ADDENDUM NO. 1

RE: Item #2, March 22, 2023 Letting - P 6403(10), PCN 08P3, Pennington County - Grading, **Drainage, Base Course, Asphalt Concrete Surfacing**

PLANS: Please destroy sheets 2, 8, 14, 15, 26-28, 30-32, 126, & 127 and replace with the enclosed

SHOT ROCK ROAD SECTION

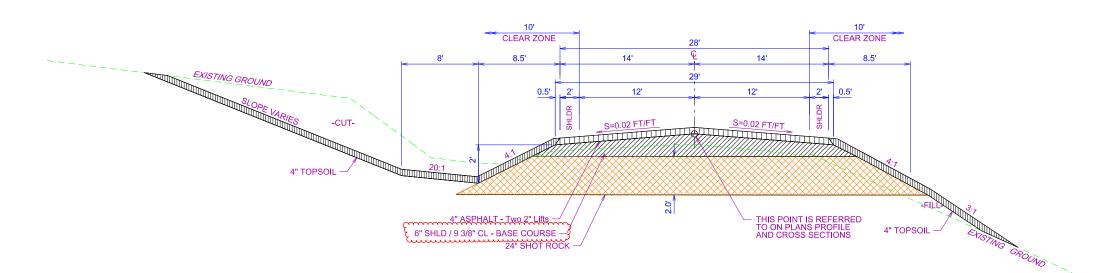
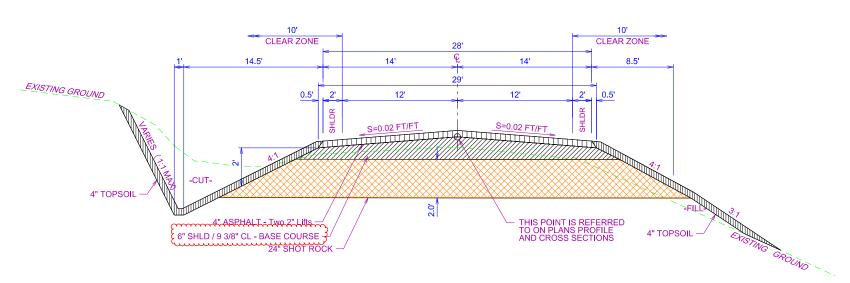
Sheets 26-28: Typical Sections were revised.

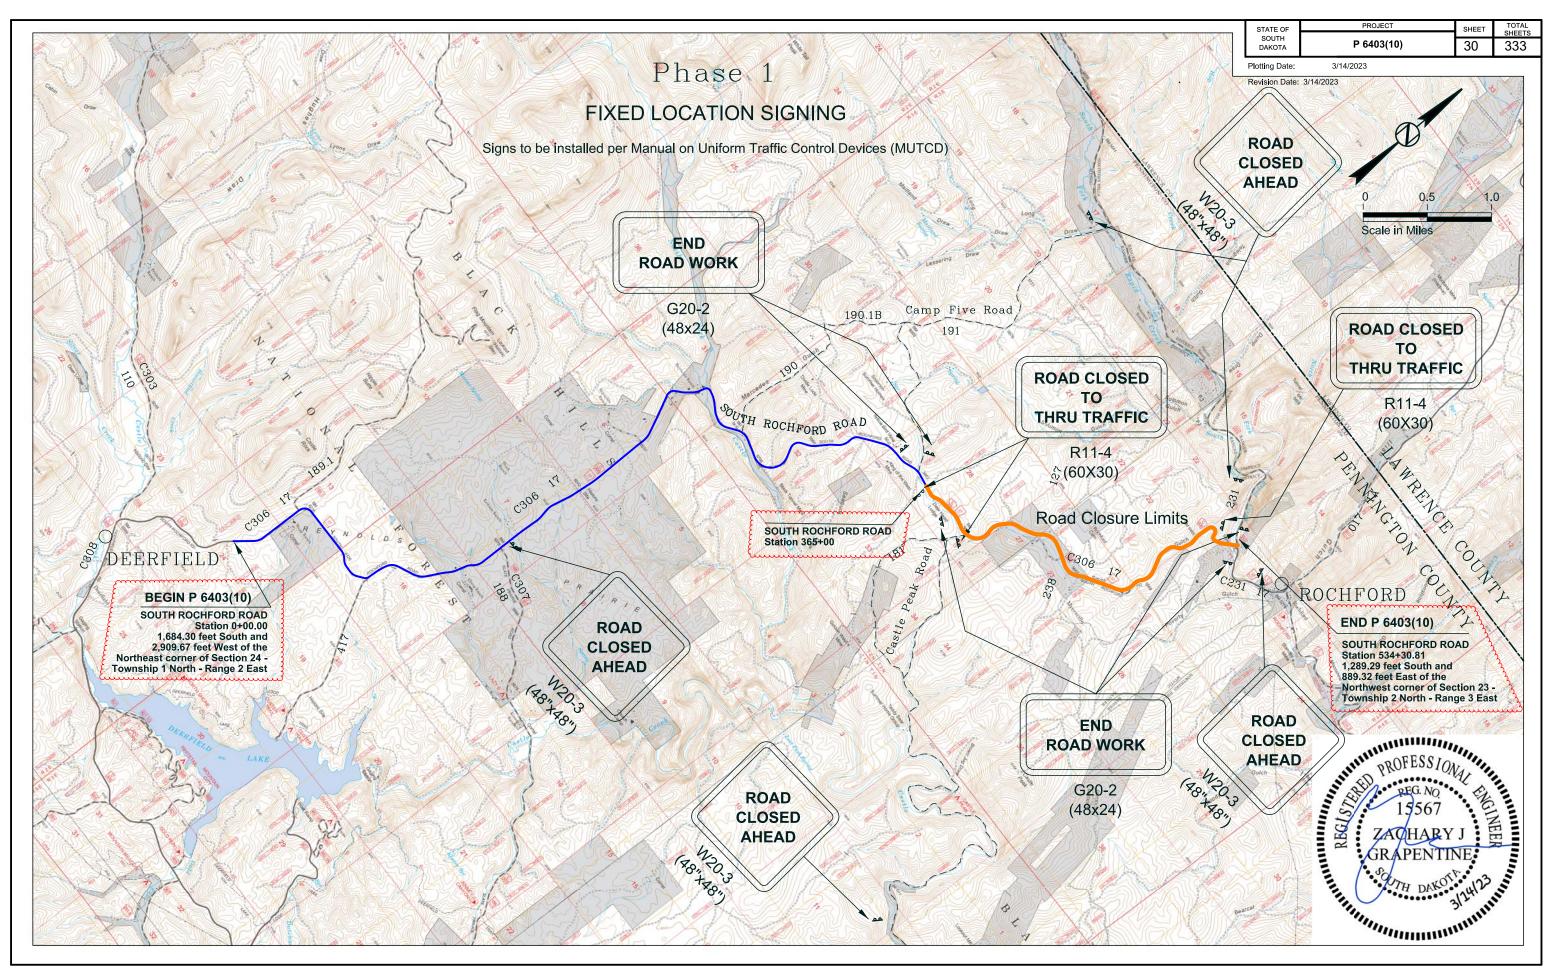
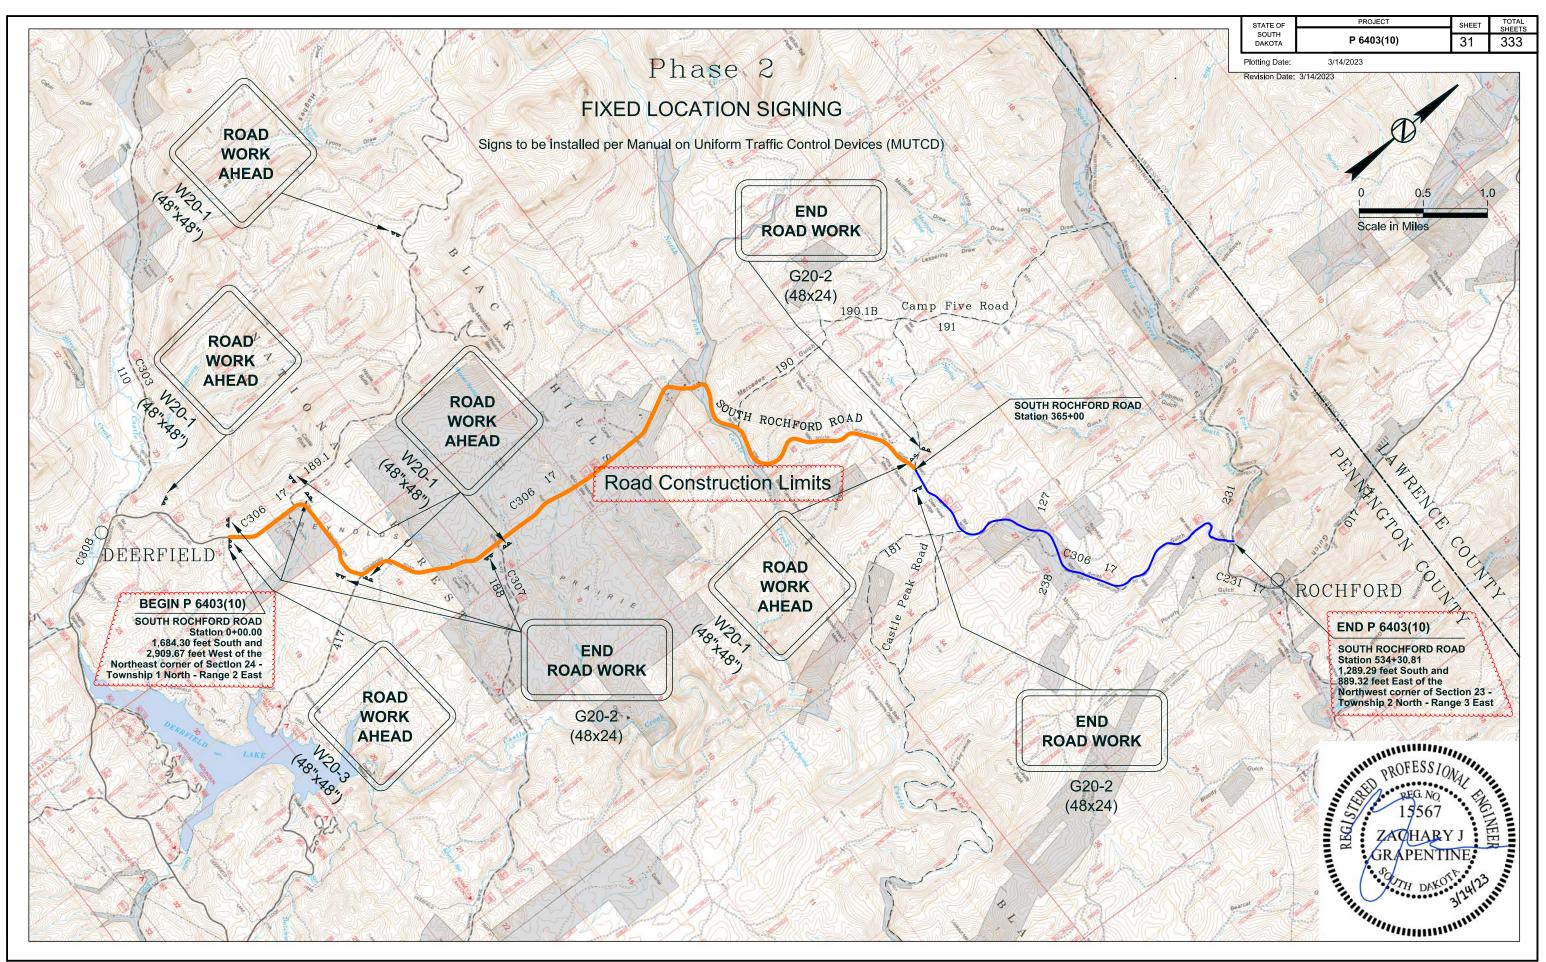
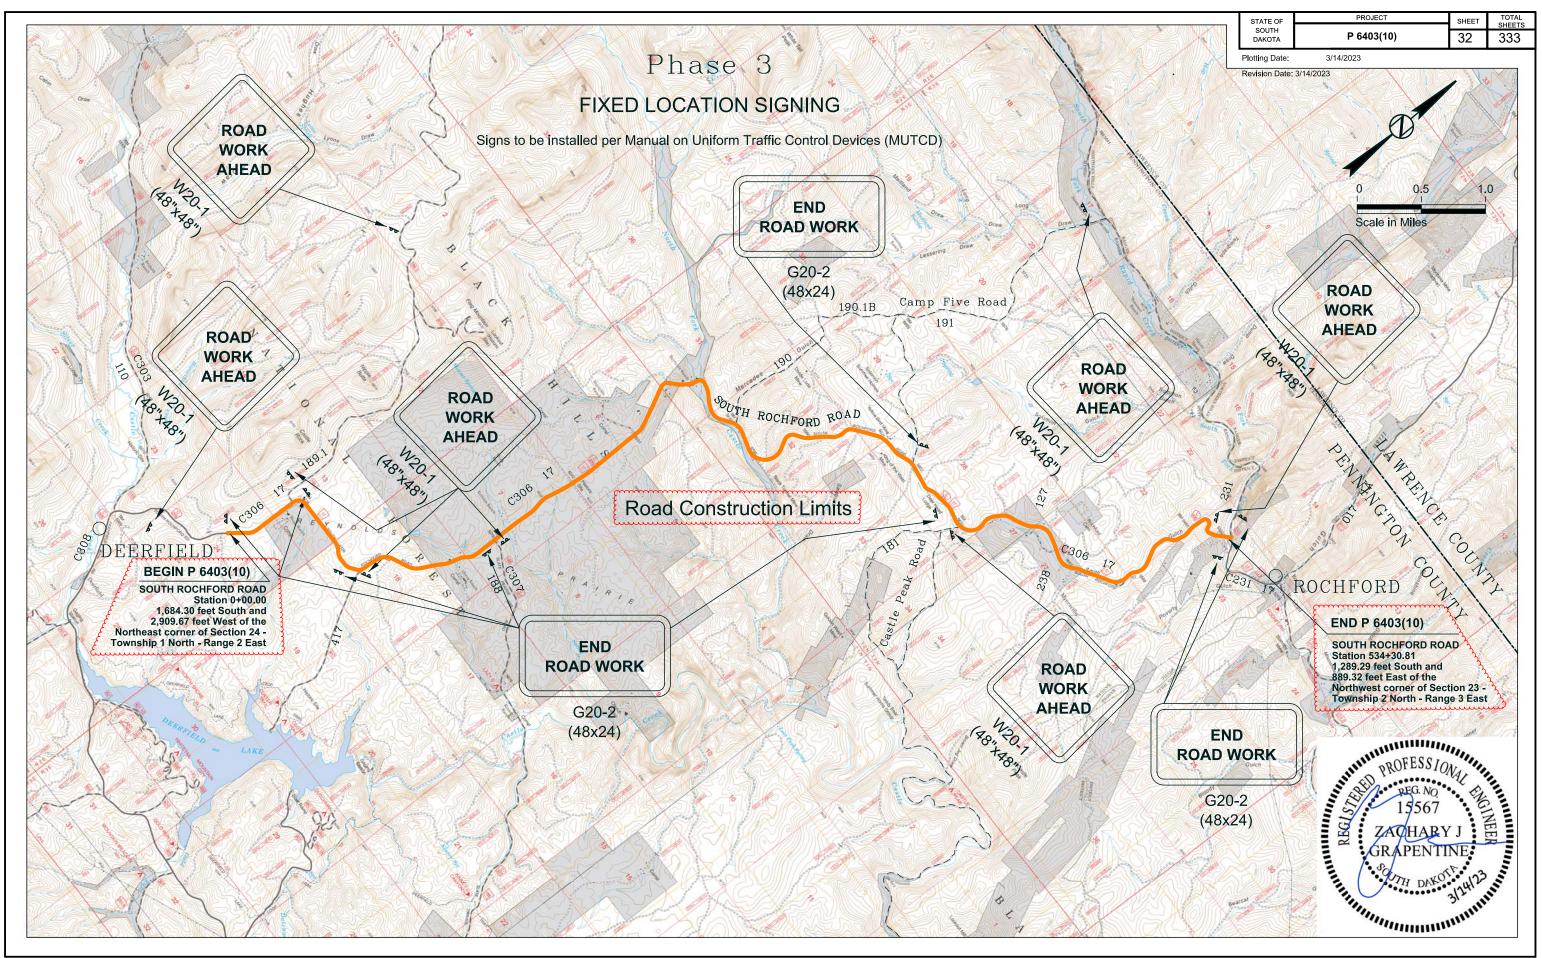
Sheet 30: Phase 1 FIXED LOCATION SIGNING sheet was revised.

Sheet 31: Phase 2 FIXED LOCATION SIGNING sheet was revised.

Sheet 32: Phase 3 FIXED LOCATION SIGNING sheet was revised.
